From: Holden, Leslie E.:(GenCo-Nuc) [Leslie.Holden@exeloncorp.com]
Sent: Thursday, January 30, 2014 2:24 PM
To: Wiebe, Joel
Cc: Borton, Kevin F:(GenCo-Nuc); Gullott, David M.:(GenCo-Nuc)
Subject: RE: Braidwood/Byron MUR Package for Proprietary and Factual Error Review - Part 2
Attachments: 20140130 MUR Package for Proprietary and Factual Error Review - Part 2 LEH.docx

From: Wiebe, Joel [<mailto:Joel.Wiebe@nrc.gov>]
Sent: Thursday, January 30, 2014 7:23 AM
To: Holden, Leslie E.:(GenCo-Nuc)
Subject: Braidwood/Byron MUR Package for Proprietary and Factual Error Review - Part 2

3.1.1.3 Evaluation of Trends for Byron, Unit No. 1

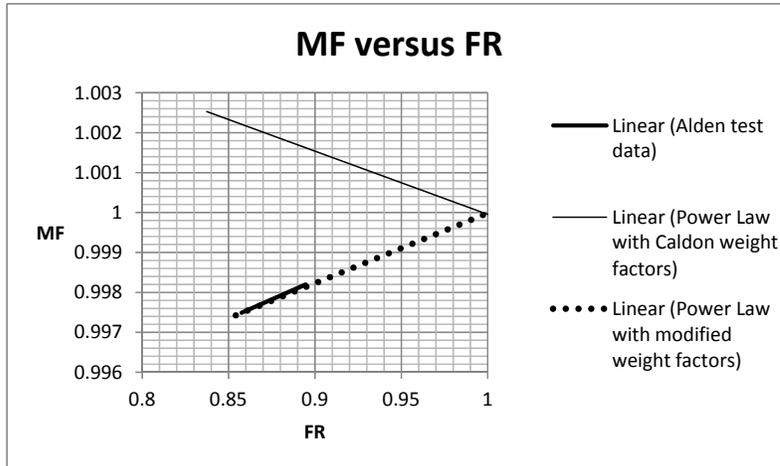
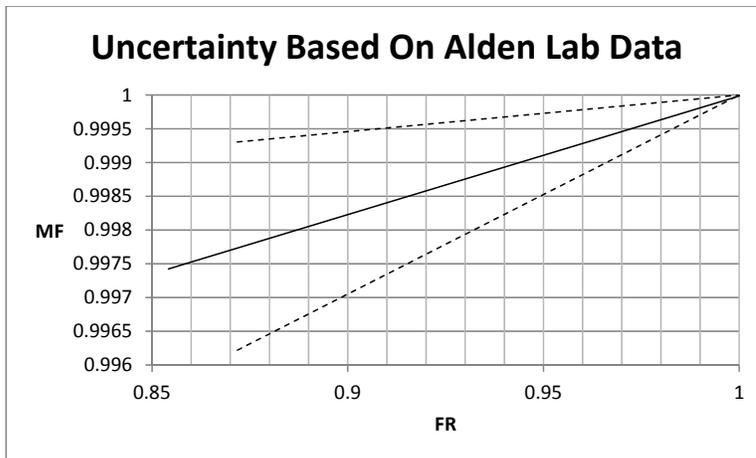
Page 15/20 - 2nd ¶ after table beginning "Estrada" – May want to consider restating or deleting or rewording the 3rd sentence; *"The NRC staff does not understand the rationale for fitting ARL data where MFs were less than one to a line where the MFs were greater than one."*

Comment [LEH3]: Joel, do you really want to put this in that the NRC staff does not understand?
